ORIGINATION FORM

Proposed Revisions to a Standard Plans Index (Please provide all information — Incomplete forms will be returned)

Index Number: 430-040
Sheet Number (s): 1 and 2 of 2
Index Title: Winged Concrete Endwalls

===== WINGED CONCRETE ENDWALLS =====

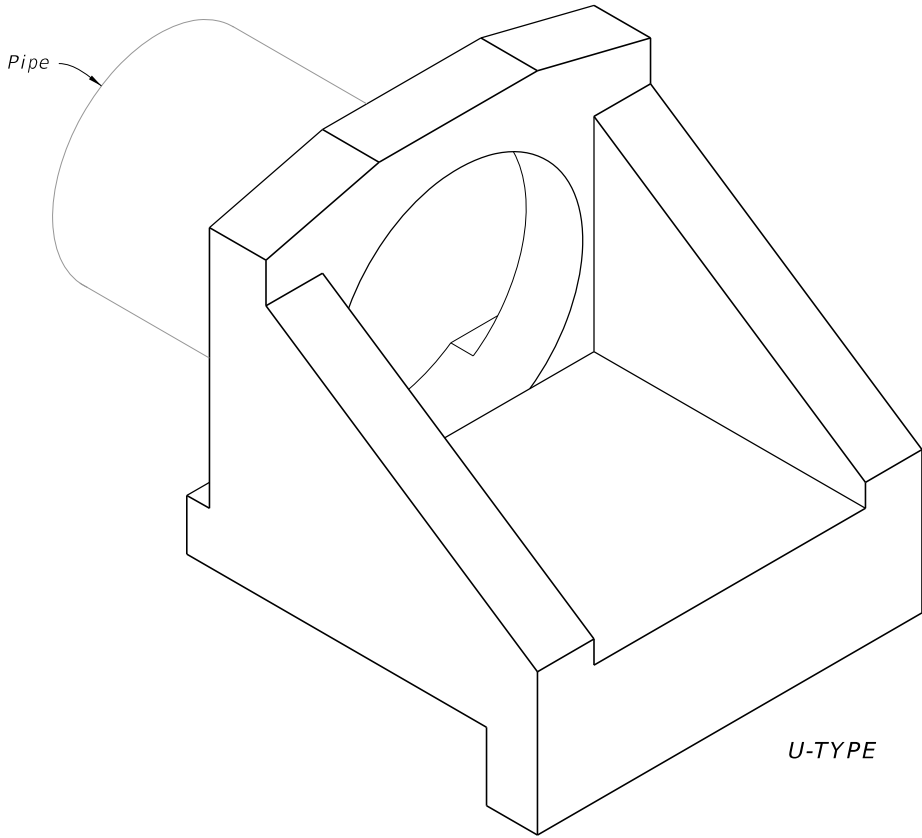
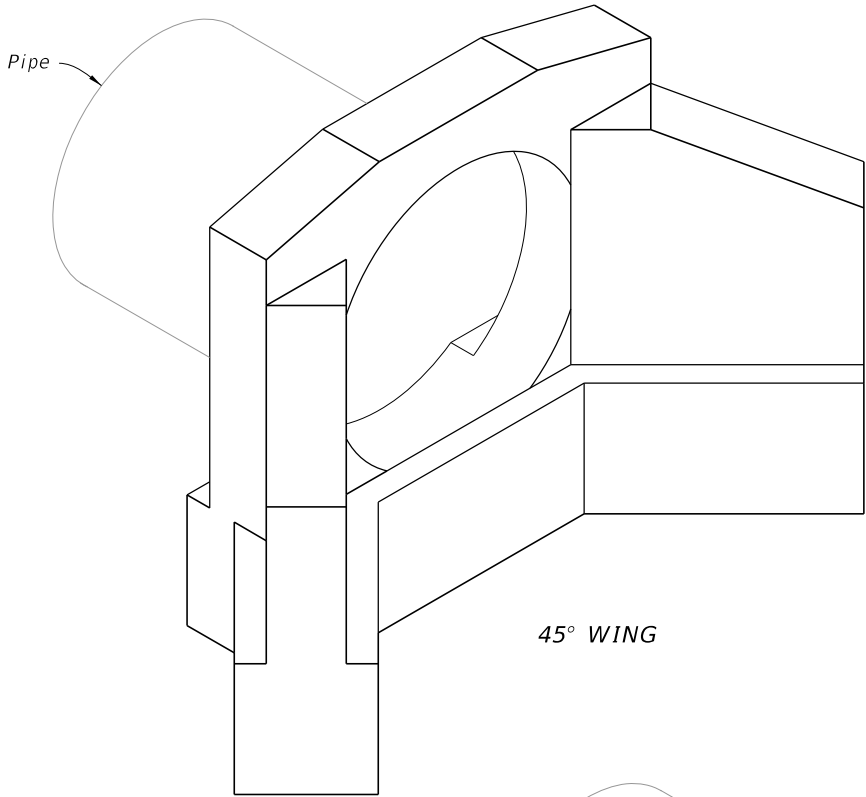
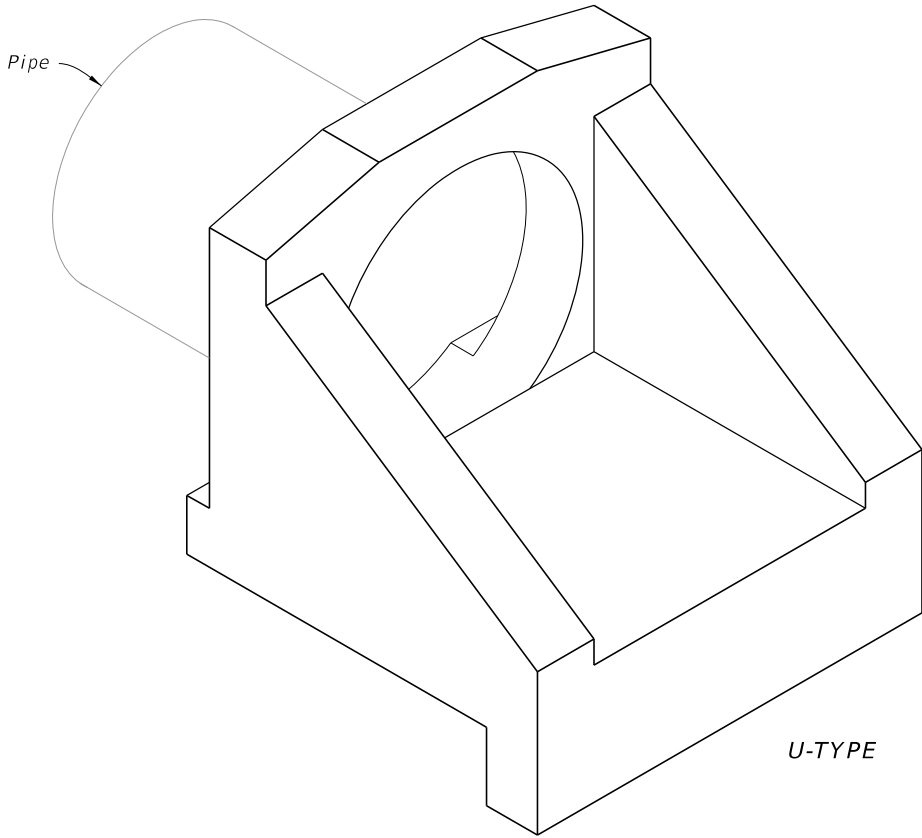
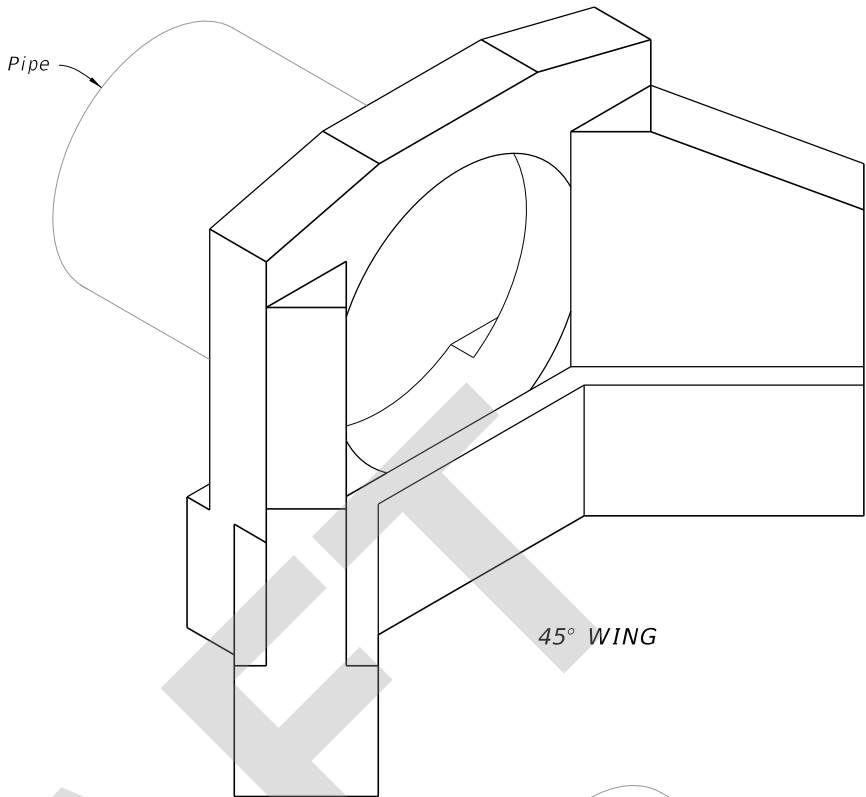
Sheet 1: Changed GENERAL NOTE 1 from "Class I" to "Class II".

1. ~~Use Class I concrete.~~ ← **CHANGED TO: Class II**
2. ~~Chamfer all exposed edges and corners $\frac{3}{4}$ " unless otherwise shown.~~
3. Quantities shown are for estimating purposes only.

- 1. Use Class II concrete.
- 2. Chamfer all exposed edges and corners $\frac{3}{4}$ " unless otherwise shown.
- 3. Quantities shown are for estimating purposes only.

U-TYPE AND 45° ENDWALLS

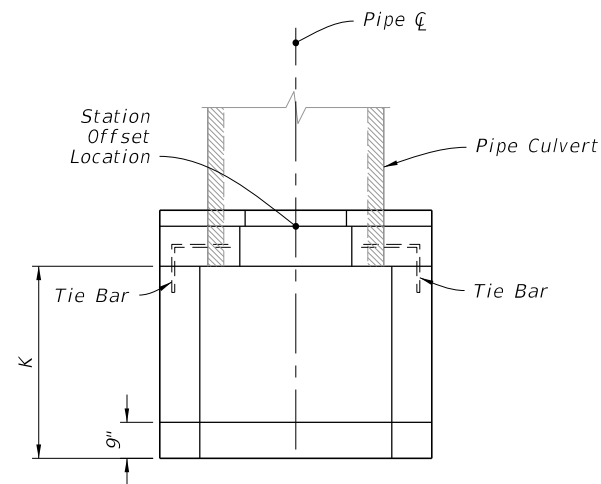
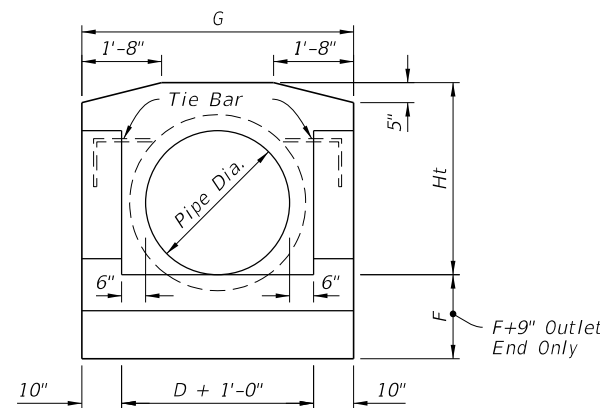
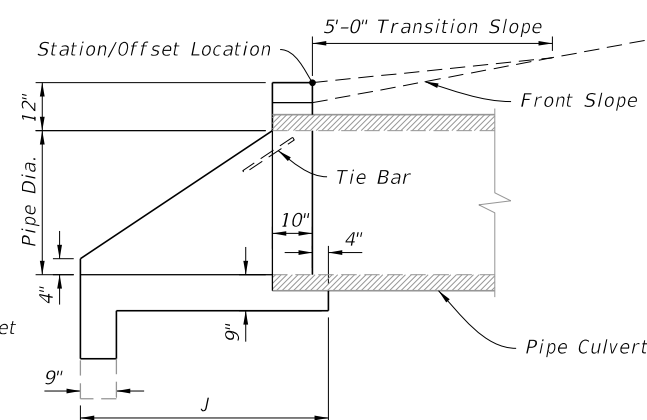
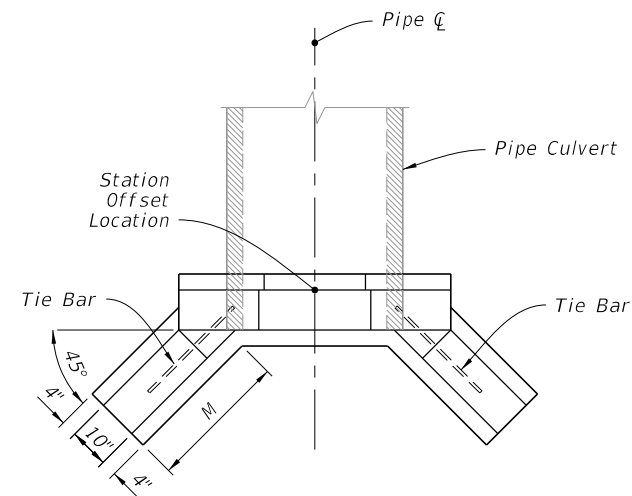
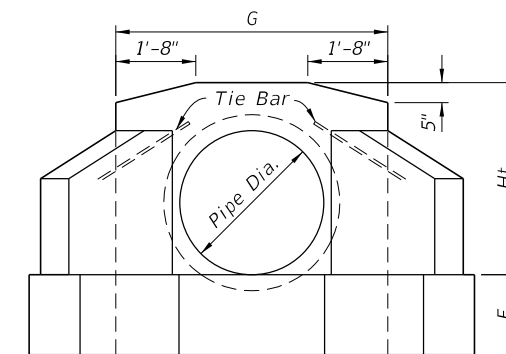
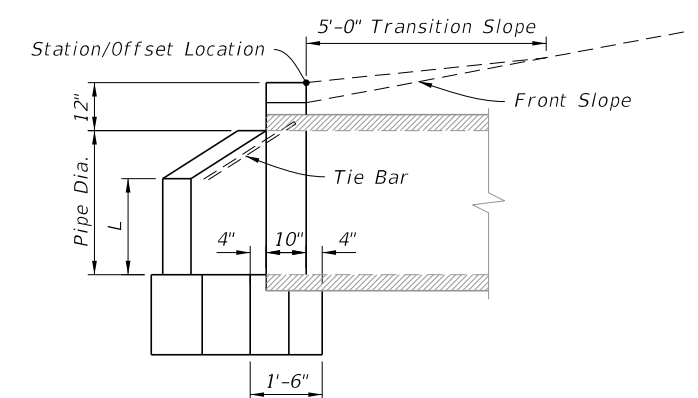
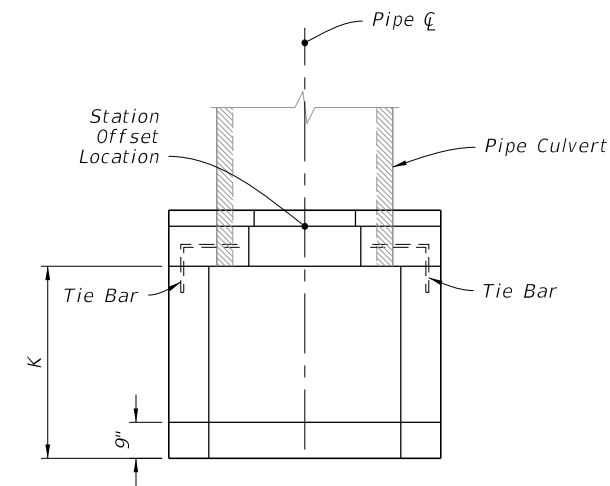
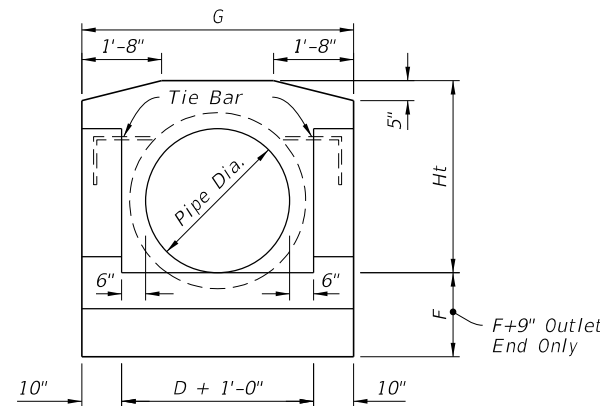
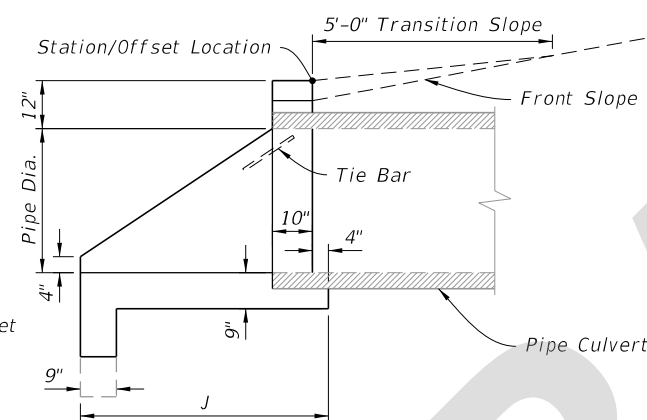
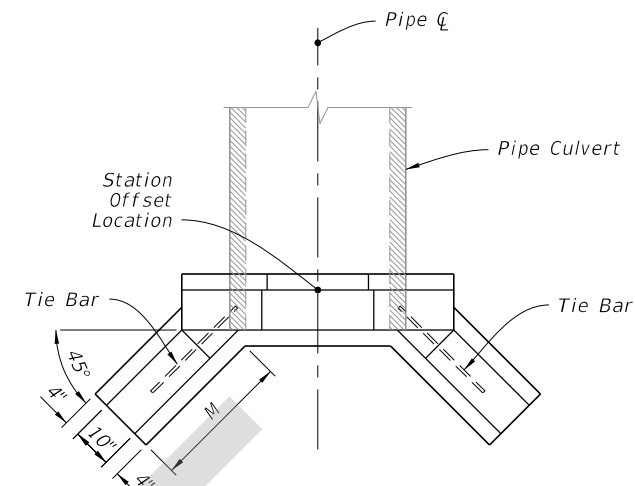
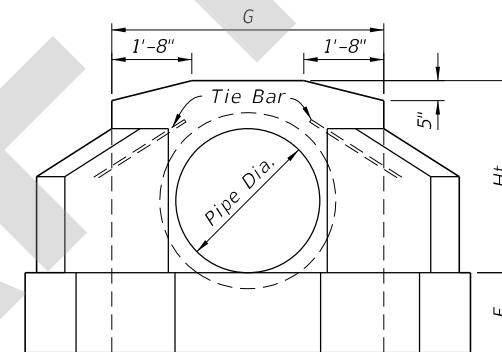
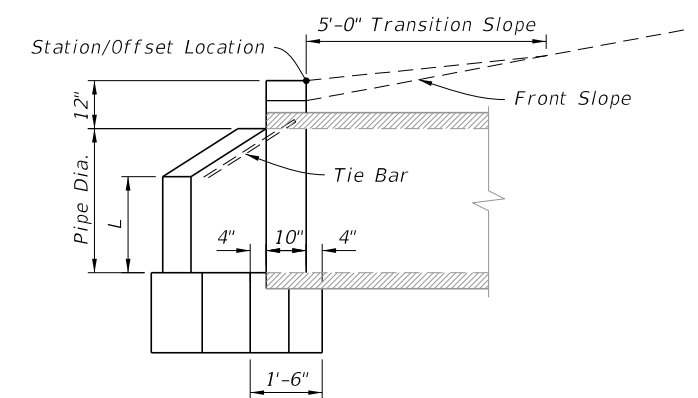
Sheet 2: Changed "Class I" to "Class II" in the DIMENSION AND ESTIMATED QUANTITIES TABLES.

CHANGED TO: Class II

DIMENSIONS AND ESTIMATED QUANTITIES PIPE CULVERT ENDWALLS WITH U-TYPE WINGS													
DIMENSIONS							QUANTITIES IN ONE ENDWALL						
Pipe		Wall			Footing		Concrete, Class II, Total (CY)						Steel Tie Bars
Dia. D	Area (ft²)	G	Ht	K	F	J	RCP		CMP		CIP		
							Inlet	Outlet	Inlet	Outlet	Inlet	Outlet	
15"	1.2	3'-11"	2'-3"	1'-5"	1'-3"	2'-7"	0.59	0.67	0.62	0.70	0.61	0.70	none
18"	1.8	4'-2"	2'-6"	1'-9"	1'-3"	2'-11"	0.70	0.79	0.74	0.82	0.74	0.82	none
24"	3.1	4'-8"	3'-0"	2'-6"	1'-6"	3'-8"	1.01	1.11	1.06	1.16	1.06	1.16	2-#6 Bars x 2'-0"
30"	4.9	5'-2"	3'-6"	3'-3"	1'-6"	4'-5"	1.33	1.44	1.41	1.51	1.40	1.51	2-#6 Bars x 2'-0"
36"	7.1	5'-8"	4'-0"	4'-0"	1'-9"	5'-2"	1.73	1.85	1.84	1.96	1.82	1.94	2-#6 Bars x 2'-6"
42"	9.6	6'-2"	4'-6"	4'-9"	2'-0"	5'-11"	2.19	2.32	2.32	2.45			2-#6 Bars x 2'-6"
48"	12.6	6'-8"	5'-0"	5'-6"	2'-0"	6'-8"	2.64	2.78	2.81	2.95			2-#6 Bars x 3'-0"

DIMENSIONS AND ESTIMATED QUANTITIES PIPE CULVERT ENDWALLS WITH 45° WINGS											
DIMENSIONS							QUANTITIES IN ONE ENDWALL				
Pipe		Wall				Footing	Concrete, Class II			Steel Tie Bars	
Dia. D	Area (ft²)	Ht	G	L	M	F	Total (CY)				
							RCP	CMP	CIP		
15"	1.2	2'-3"	3'-7"	1'-0"	1'-3"	1'-3"	0.56	0.59	0.59	none	
18"	1.8	2'-6"	3'-10"	1'-2"	1'-7"	1'-3"	0.74	0.77	0.77	none	
24"	3.1	3'-0"	4'-4"	1'-5"	2'-1"	1'-4"	1.01	1.06	1.06	2 -#6 Bars x 2'-0"	
30"	4.9	3'-6"	4'-10"	1'-9"	2'-5"	1'-6"	1.32	1.40	1.39	2 -#6 Bars x 2'-0"	
36"	7.1	4'-0"	5'-4"	2'-0"	2'-11"	1'-8"	1.72	1.83	1.82	2 -#6 Bars x 2'-6"	
42"	9.6	4'-6"	5'-10"	2'-3"	3'-6"	2'-0"	2.34	2.47		2 -#6 Bars x 2'-6"	
48"	12.6	5'-0"	6'-4"	2'-6"	4'-0"	2'-0"	2.74	2.90		2 -#6 Bars x 2'-6"
